10GBASE-T start up: new concepts and proposed text

Gottfried Ungerboeck, Broadcom Corporation

Figure 55-aa—Interaction between Auto Negotiation and PHY Control

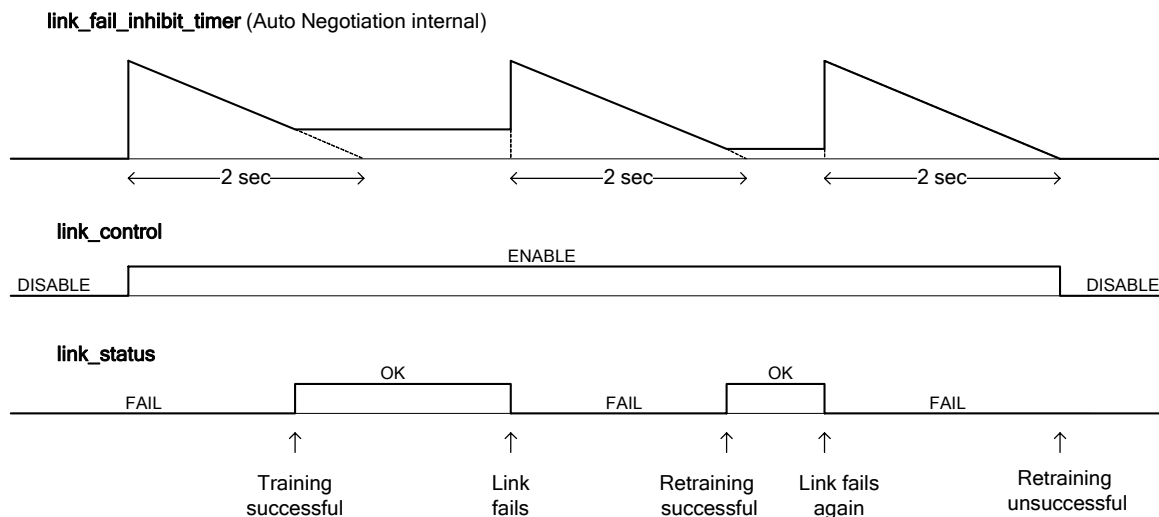
Auto Negotiation controls PHY Control through variable `link_control` $\in \{\text{DISABLE}, \text{ENABLE}\}$ and specifies PHY operation further through additional variables, e.g., `config` $\in \{\text{MASTER}, \text{SLAVE}\}$. PHY Control provides variable `link_status` $\in \{\text{FAIL}, \text{OK}\}$. The interaction between Auto Negotiation and PHY Control is illustrated in Figure 55-aa.

Assertion of `link_control` = **DISABLE** by Auto Negotiation forces PHY Control unconditionally into state **PHY_Disabled**. In state **PHY_Disabled**, the PHY is silent, signals `link_status` = **FAIL**, and waits for being enabled by Auto Negotiation.

When Auto Negotiation sets link_control = ENABLE, PHY Control begins the PMA training process. AutoNegotiation also starts the internal link_fail_inhibit_timer at a nominal value of 2 sec. PHY Control is given this maximum time to reach state PCS_Data, where it sets link_status = OK. *[When Auto Negotiation observes link_status = OK, it may stop the link_fail_inhibit_timer or let it continue to count down to zero and stop there.]*

During normal PHY operation in state PCS_Data, a failure situation may occur causing PHY Control to return to state Silent, set link_status = FAIL, and then begin PMA retraining. When Auto Negotiation observes the transition of link_status from OK to FAIL while link_control = ENABLE, the link_fail_inhibit_timer is restarted at a nominal value of 2 sec. *[or a smaller value for retraining?]* This gives PHY Control another opportunity to reach state PCS_Data within this maximum time.

When the link_fail_inhibit_timer has counted down to zero and PHY Control has not yet signaled link_status = OK, Auto Negotiation sets link_control = DISABLE and thus forces PHY Control to return to state PHY_Disabled.

Figure 55-bb—InfoField format and payloads

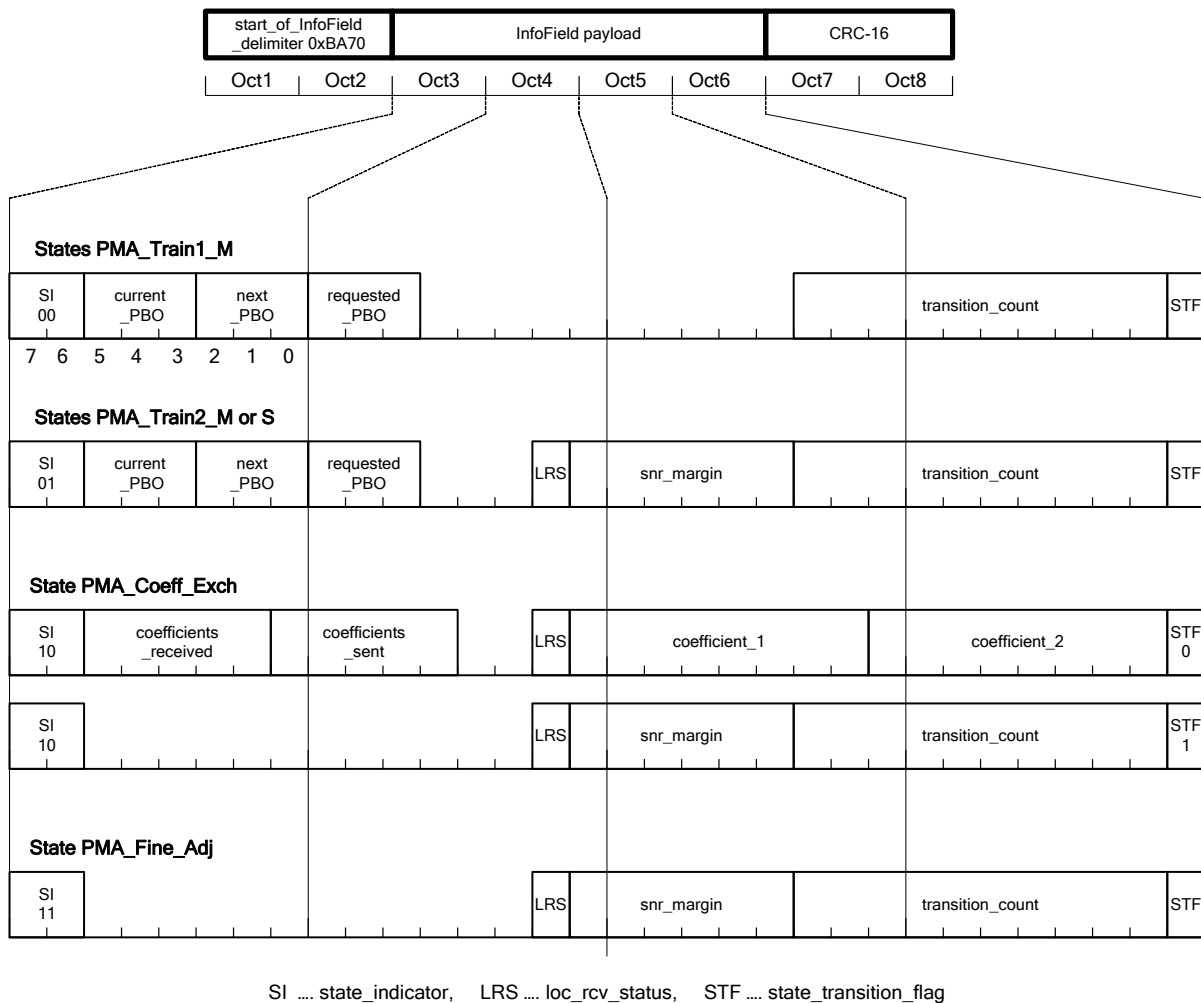
[In some implementations, the resources required to decode an InfoField will be proportional to the length of the InfoField. This provides one motivation to shorten the InfoField from 16 octets as in Draft 2.2 to 8 octets (or even smaller length). Avoiding wasteful use of bit positions and redundancies as in the InfoFields of Draft 2.2 is another reason.]

The InfoField and its state dependent payloads are depicted in Figure 55-bb. The InfoField comprises 8 octets. The first two octets provide a start_of_InfoField_delimiter (Oct1:2), which contains the hexadecimal value 0xAB70, i.e., the binary sequence 1010101101110000 *[or whatever]*. The next four octets convey the InfoField payload (Oct3:6), which is checked by a 2-octet CRC-16 (Oct7:8). Unused bit positions in the payload may be set in the transmitter to arbitrary values and are ignored upon reception.

[...This definition of CRC-16 is more compact but otherwise equivalent to the pictorial definition given in Draft 2.2, Figure 55-22. ... Protecting 4 payload octets by a CRC-16 may be considered as overkill; CRC-8 may be sufficient. Using a shortened RS or BCH code instead of a CRC may be another option.]

[Notice that there are no fields $THP \in \{THP_{Byt}, THP_{Short}, THP_{Med}, THP_{Long}\}$. The specification of these fields in the InfoField format of Draft 2.2 is redundant and hence not needed. If fixed precoding is requested for the transmission of PMA training frames in states PMA_Train1_M and PMA_Train2_M (corresponding in Draft 2.2 to state PMA_Training_Init_M) and state PMA_Train2_S (corresponding in Draft 2.2 to state PMA_Training_Init_S), the value of THP is implied by the value of PBO; see Draft 2.2, section 55.4.2.5.11: PBO = 7 implies $THP = THP_{Short}$, PBO = 5 implies $THP = THP_{Med}$, PBO = 3 implies $THP = THP_{Long}$].

Figure 55-cc— PHY Control state diagram and relation with Auto Negotiation

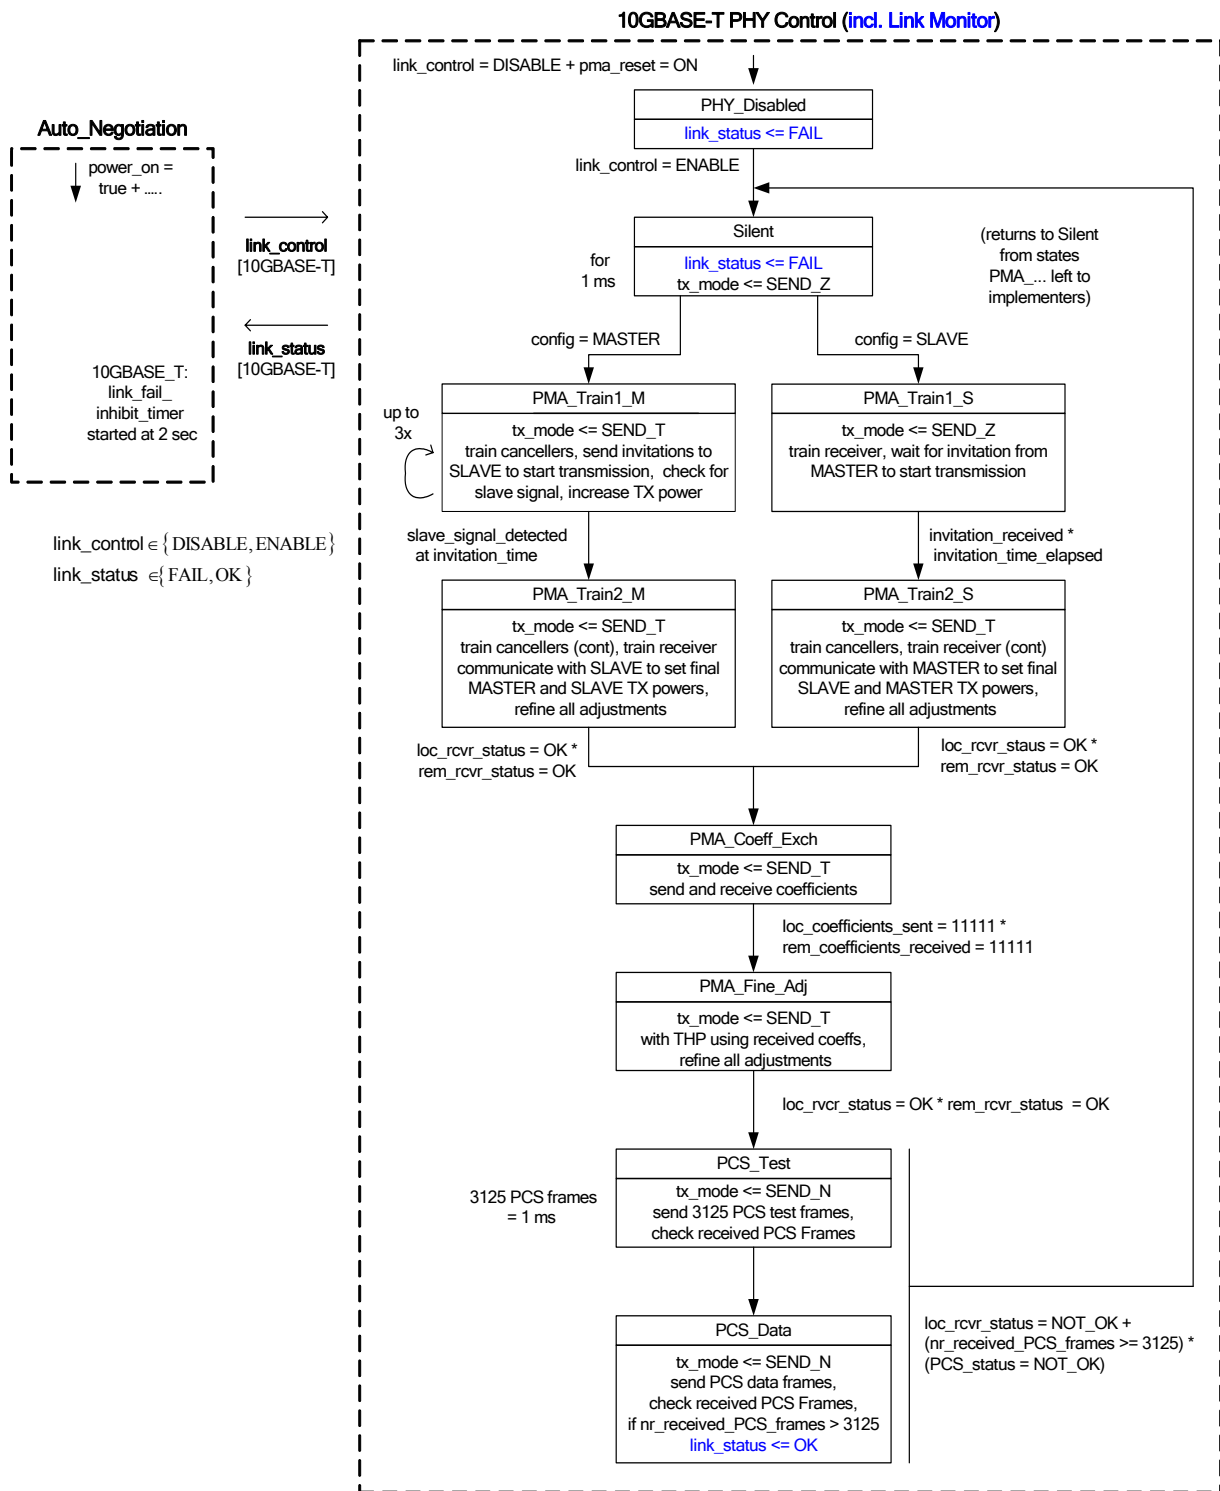
[10GBASE-T] PHY Control performs the control actions that are needed to bring a 10GBASE-T PHY into a mode of operation during which PCS data frames are exchanged with the link partner. PHY Control shall comply with the state diagram description given in Figure 55-cc. The figure also depicts the Auto Negotiation function defined in Clause 28. Auto Negotiation and PHY Control are envisaged as processes, which operate in parallel and communicate with each other through the exchange of variables.

When Auto Negotiation sets `link_control` from DISABLE to ENABLE, PHY Control proceeds from state PHY Disabled to state Silent.

In state Silent, the PHY remains silent (`tx_mode` = SEND_Z) for a fixed period of 1 ms. Then, if `config` = MASTER, PHY Control enters state `PMA_Train1_M`. Otherwise, `config` = SLAVE and PHY Control enters state `PMA_Train1_S`.
